APPLICATION NO.	FILING DATE	FIRST NAMED INVENTOR	ATTORNEY DOCKET NO.	CONFIRMATION NO.
10/663,918	09/16/2003	Richard A. Wilsak	37,512	2288
7590	12/23/2008			
BP America Inc. Docket Clerk, BP Legal, M.C. 5East 4101 Winfield Road Warrenville, IL 60555		EXAMINER POPOVICS, ROBERT J		
		ART UNIT 1797		PAPER NUMBER
		MAIL DATE 12/23/2008		DELIVERY MODE PAPER

Office Action Summary	Application No. 10/663,918	Applicant(s) WILSAK ET AL.
	Examiner /Robert James Popovics/	Art Unit 1797

DETAILED ACTION

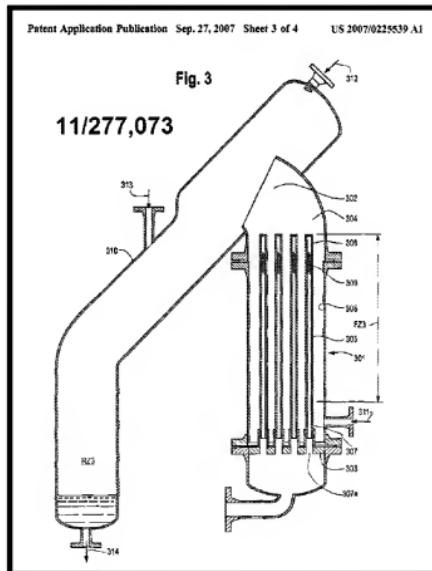
In this regard, it is noted that the only apparatus disclosed to accomplish this step is Fig. 1, which discloses an open chute 33. As such, it is unclear how the above stated step would be accomplished. It is axiomatic that a fluid under pressure will follow the path of least resistance. Referring to Fig. 1, that would be chute 33.

Comparing Figure 3 of US 2007/0225539 A1 with Fig. 1 of the instant disclosure

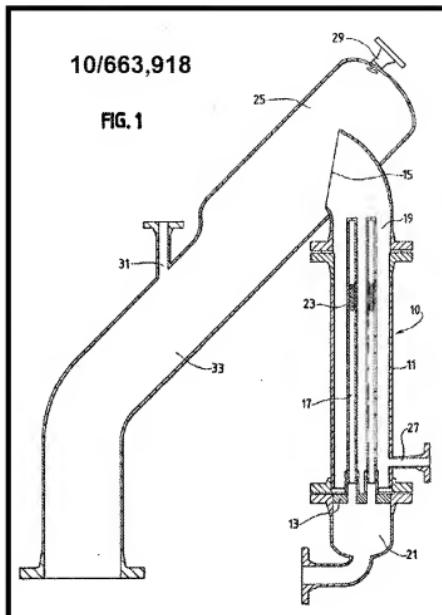
Claims 1,2,5-16,40,41,44,45,48 and 49 are rejected under 35 U.S.C. 112, first paragraph, because the **best mode** contemplated by the inventor has not been disclosed. Evidence of concealment of the best mode is based upon **Figure 3 of US 2007/0225539 A1**.

it would appear that something is missing.
